NEW PRODUCT ANNOUCEMENT

DVC TERMINATIONS (FEMALE END)

Example of Difference (CVK-H & CVK-H-F)

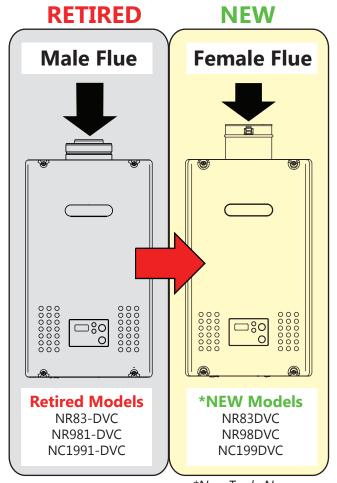
We changed flue of all NEW DVC models to prevent condesate leakage where long vent runs are applied

With this change on the DVC model's flue, the vent direction will be opposite from before

Only DVC termination vent pieces will change

*(-F) at the end of the part number is designated for (Female Flue Models)
